LETTER OF OBJECTION TO PLANNING APPLICATION REFERENCE PL/2024/05527 – LAND SOUTH OF WESTWELLS ROAD

12528L TN01– Ecology Solution Ltd Landscape Technical Note

Proposed Data Centre, Land south of Westwells Road, Neston, Corsham (planning ref: PL/2024/05527) – Landscape Matters

Figure ES1: Extract from Google Earth illustrating the view cone from EDP Viewpoint 15

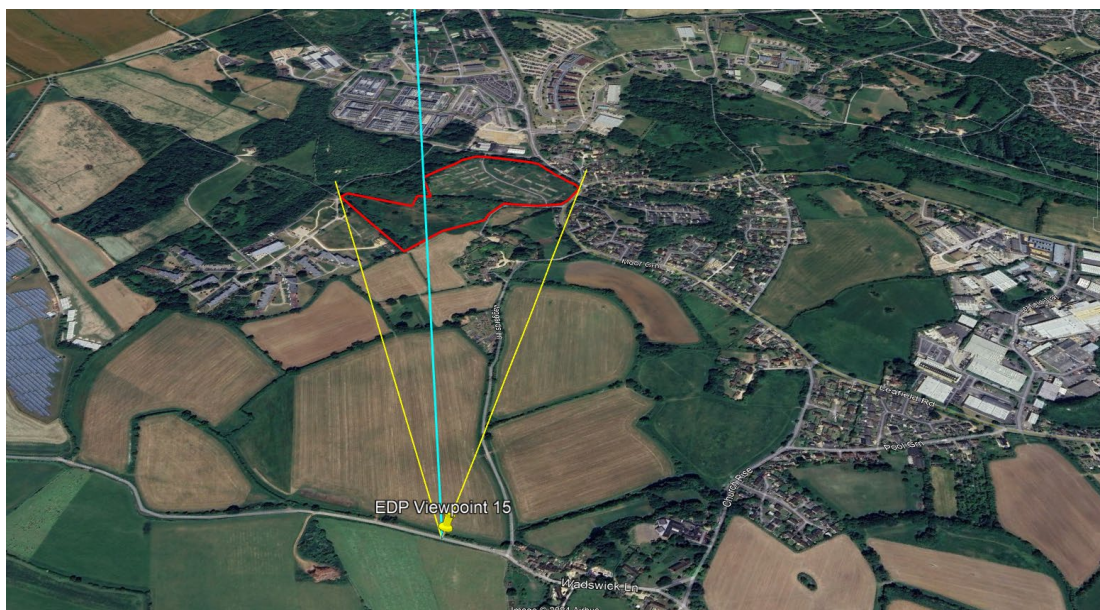
- 1.13. I would also query the location of the "approximate extent of the site" annotation on Viewpoint EDP15, which appears to be located too far to the right. The extract from Google Earth (below) illustrates the location of the view cone (yellow lines) in relation to the view towards the Telecoms mast (blue line). Based on this analysis, the telecoms mast should be located centrally within the "approximate extent of the site", with the development at Wadswick Green (to the left of the view) forming the south westerly extent of the view cone. While not a fundamental point, it does raise questions as to the level of detail and care applied to the assessment.
